Staff Report to the St. Petersburg Community Planning and Preservation Commission

For Public Hearing and Executive Action on November 7, 2017
at 2:00 p.m., in the City Council Chambers, City Hall,
175 Fifth Street North, St. Petersburg, Florida.

City File: FLUM-48

The purpose of this application is to amend the plan designation and zoning category for an existing preservation area, known as "Preservation Site N-68". According to the applicant and supporting evidence, the subject property is of poor natural quality and no longer a pine flatwood as described in the original ecological survey.

Preservation Site N-68

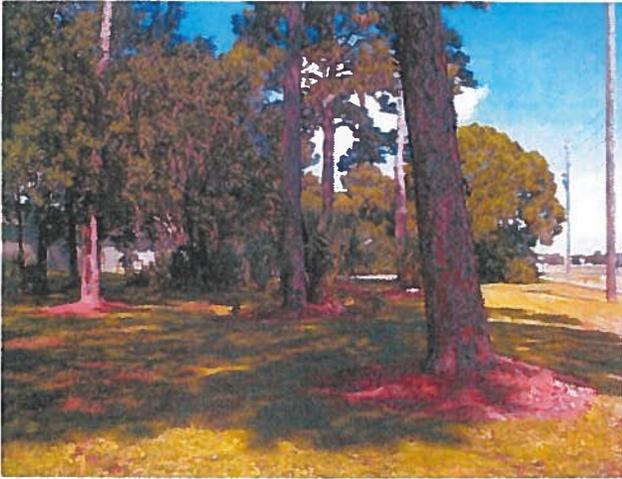
On February 25, 1983, an Ecological Survey of Preservation Site N-68 was performed and recorded by Donald Richardson, Plant Ecologist, University of South Florida ("USF"). *See attached.* The survey report generally describes the preservation area, includes an ecological description, evaluation, species list, and recommendations.

The ecological description identified the habitat of the subject area as an intermediate Pine Flatwoods, including an overstory, shrub layer, and groundcover. At the time of the survey, the *overstory* was comprised of slash pine, the *shrub layer* was comprised of five (5) different species, and the *ground cover* was comprised of nine (9) different species typical for this habitat type. Moreover, three (3) different invasive species were identified with Brazilian pepper seedlings and young shrubs posing the greatest threat to the areas ecological integrity.

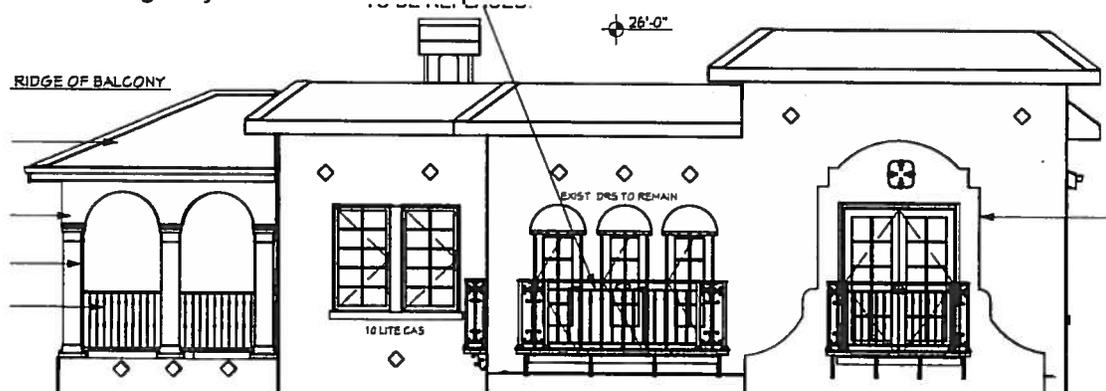
3. The relationship of width of the windows to height of windows in a building shall be visually compatible with contributing resources in the district.

For most of the building, the existing non-historic windows approved by the CPPC in 2010 are proposed to be replaced with sashes that appear more as fixed and operational casements, rather than the double-hung type, and the majority of existing openings, including none at the façade, will not be altered so there is no significant adverse effect here. New windows and an entry door will be added to the proposed elevator shaft-way, and double doors will replace existing window sets at the rear and south balcony constructs.

The proposed sizes of the windows at the elevator shaft-way appear too large and tend to overwhelm the shaft itself and the adjacent architecture, creating an odd relationship not only to the historic, but also in a general architectural sense. The windows are proposed to be opaque, which is rarely a recommended treatment. In addition, there is an aesthetic imbalance when comparing their size with the rear entry door and other rear elevation openings. These windows should be redesigned to be smaller and sills added for a proper reference. A decorative tile may also be added at mid-level in order to reference the ornamental detail found elsewhere on the upper vertical wall runs (Condition #2).
